Aspen Business Park

Response to Pre-Application/ Other
Review Comments

Wednesday, May 04, 2022

Re: Aspen Business Park Master Plan
Application Number: DA-2304-00
Case Number: 2022-7001-00

SHEET
C2
Sheet

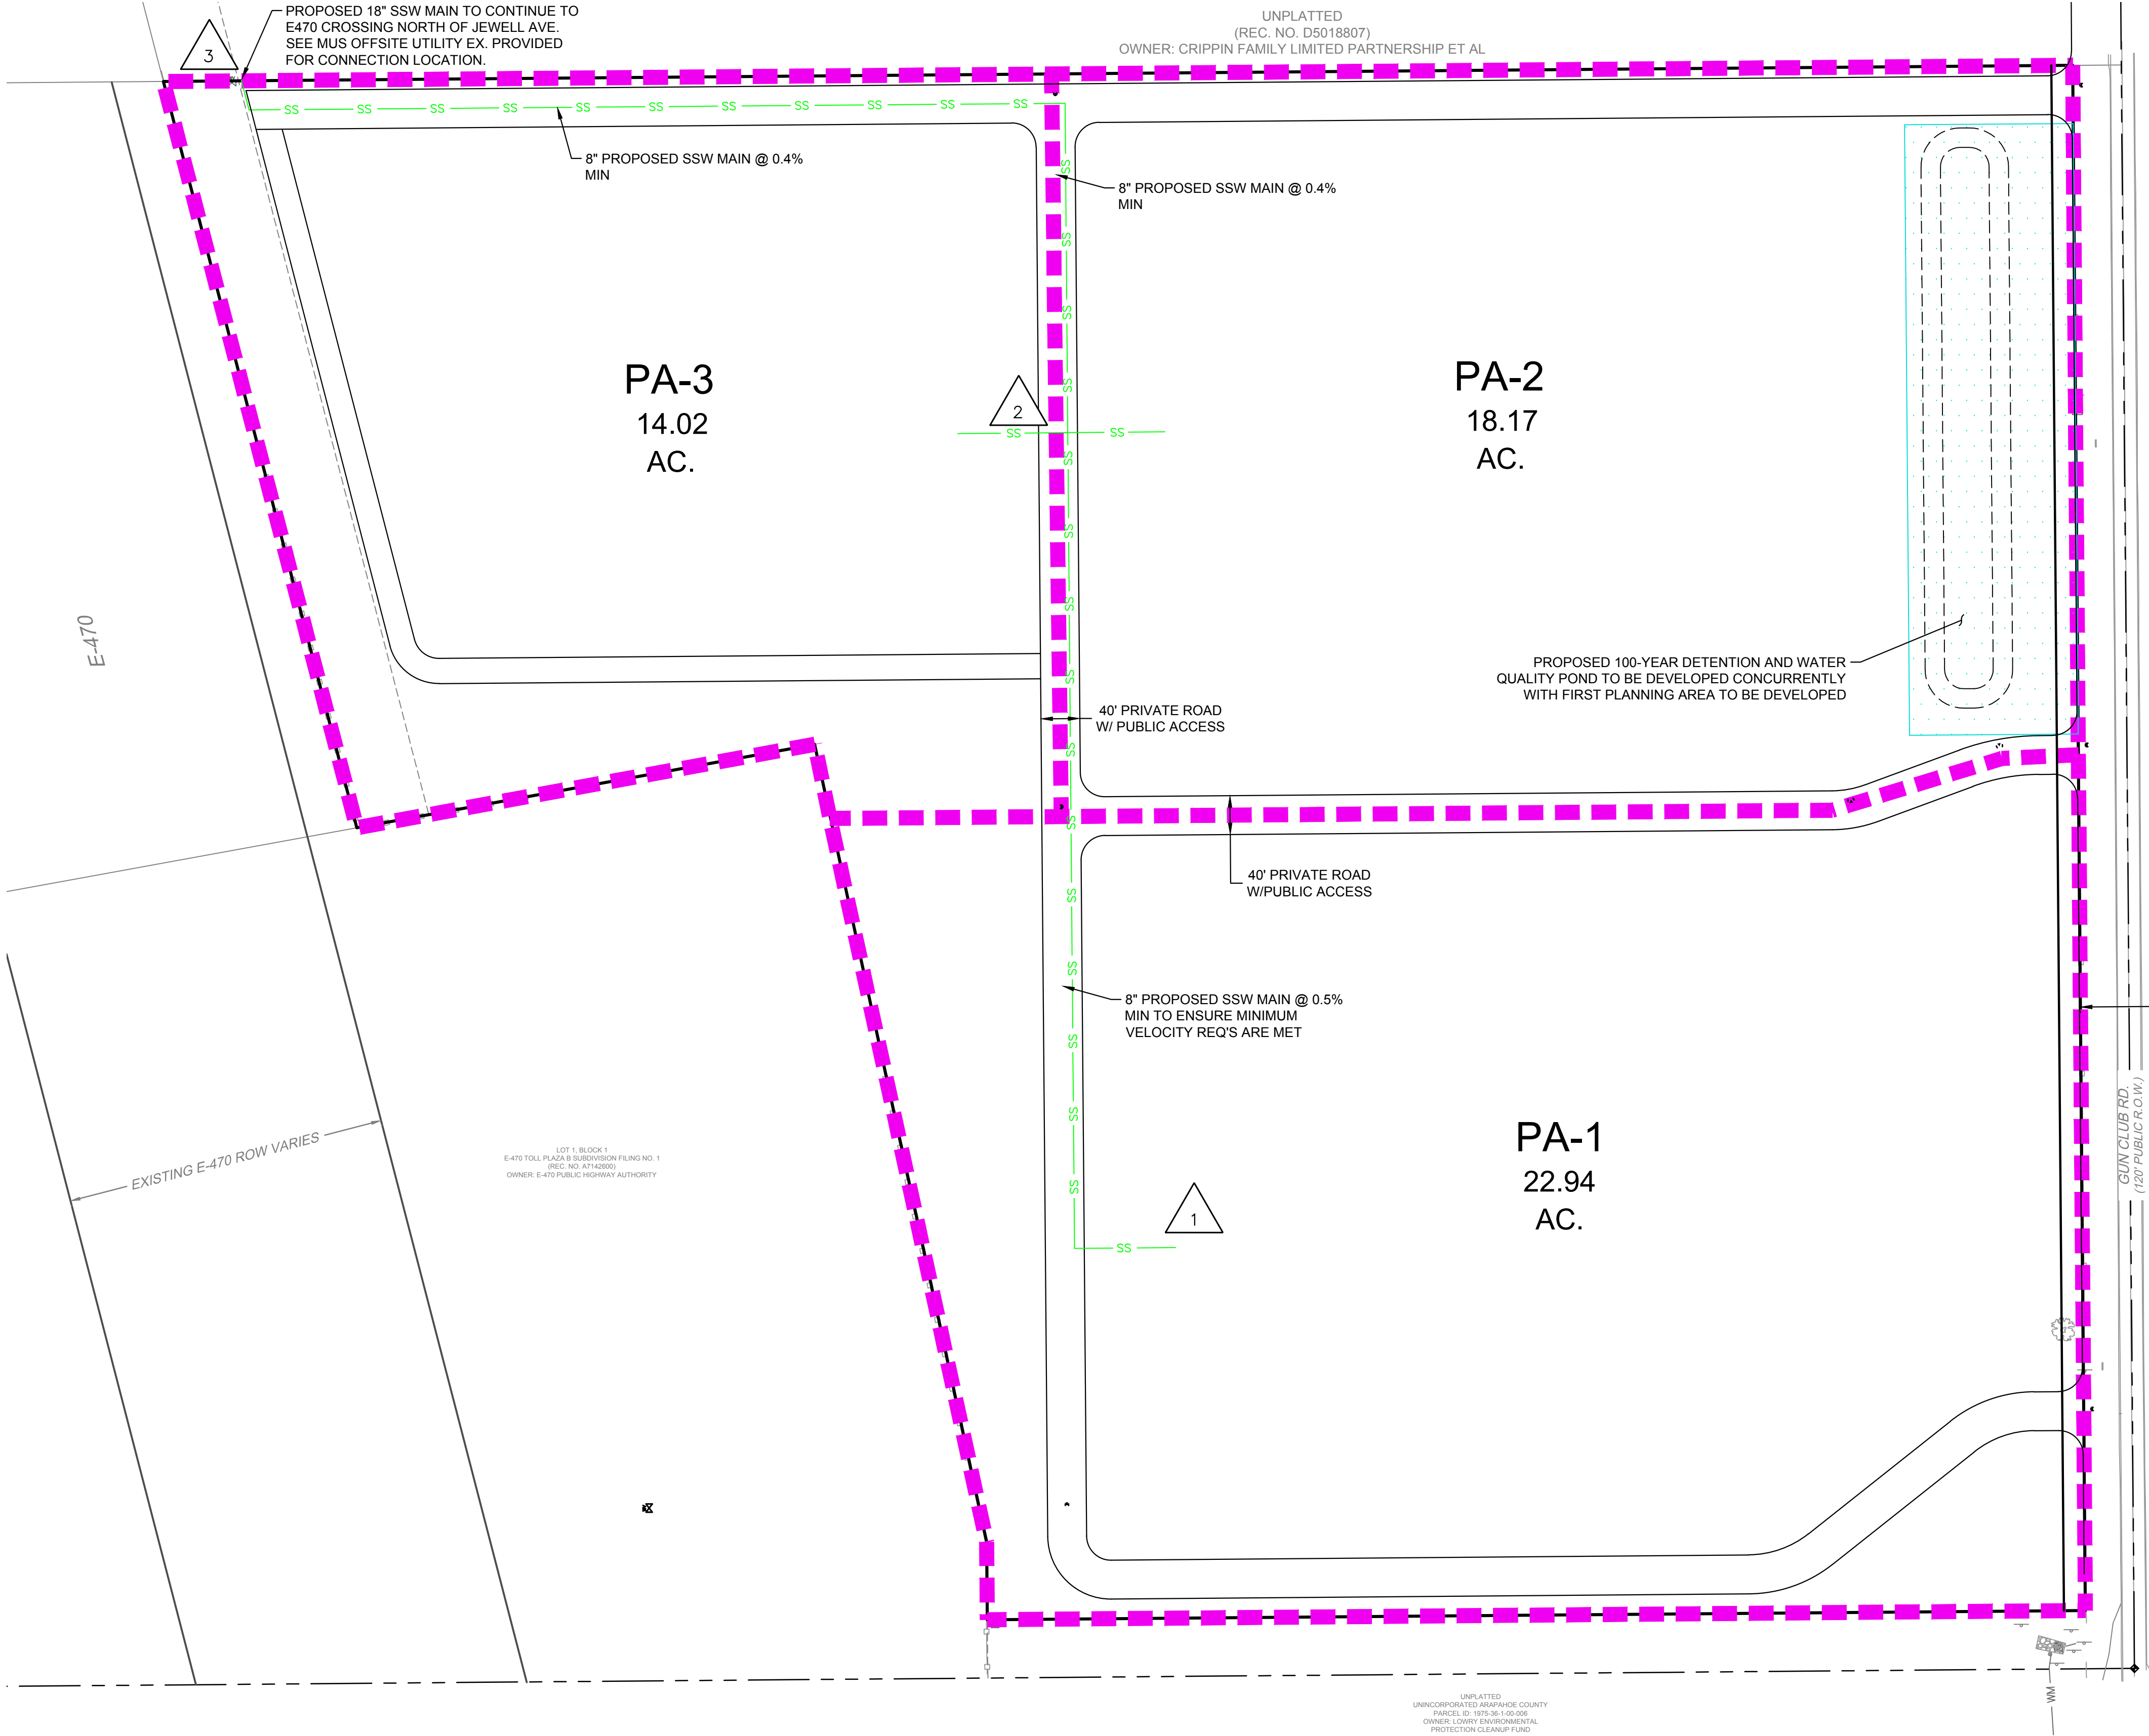
Where's
the water
exhibit?

Water exhibit was provided
on the previous sheet. If
something else is expected
please comment further.

SHEET
EX-1
Sheet

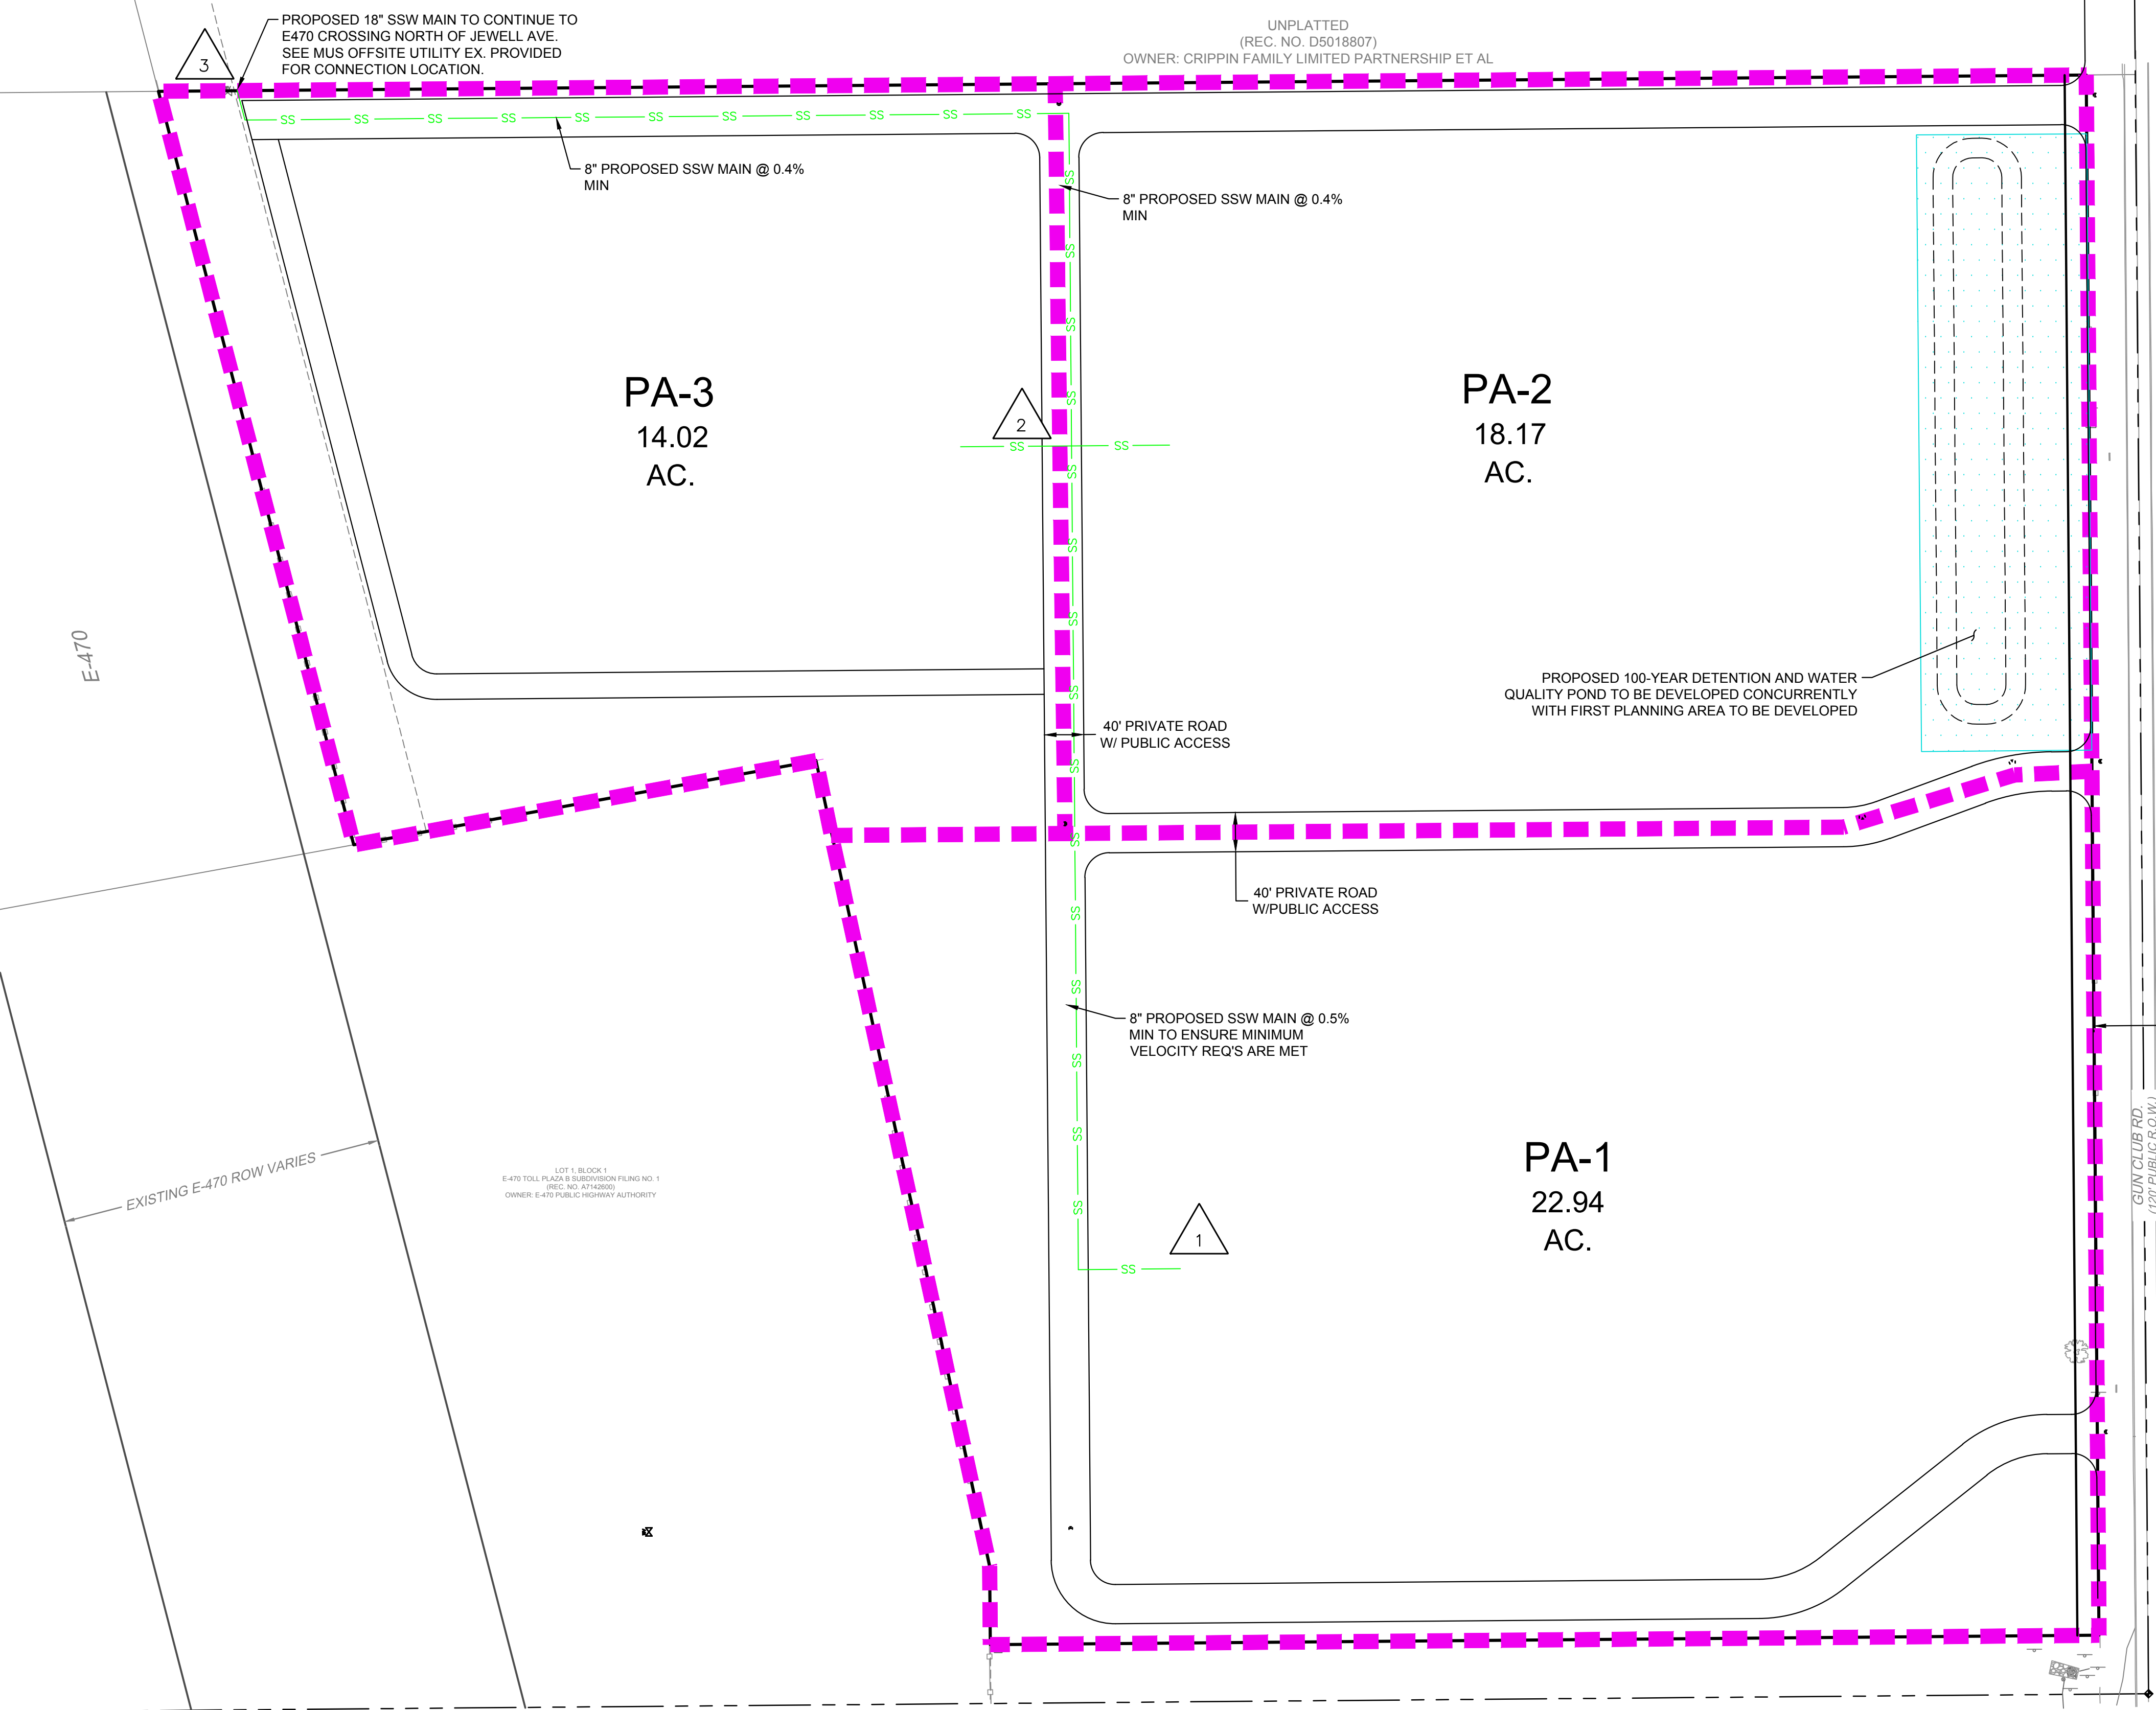
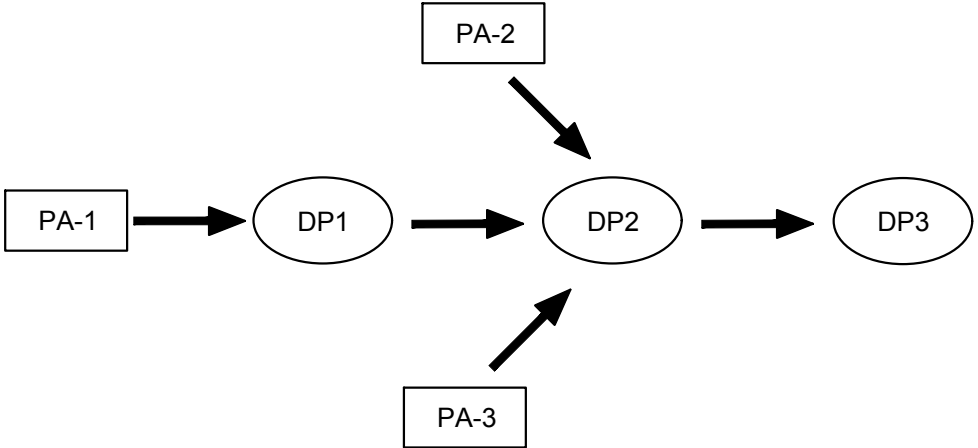
Offsite basins?

Indicate flow arrows

Offsite basin map has been added to the report to detail the size and location of offsite sanitary flow per comment.

Flow arrows have been added to plan to indicate the direction of flow for the sanitary system per comment.
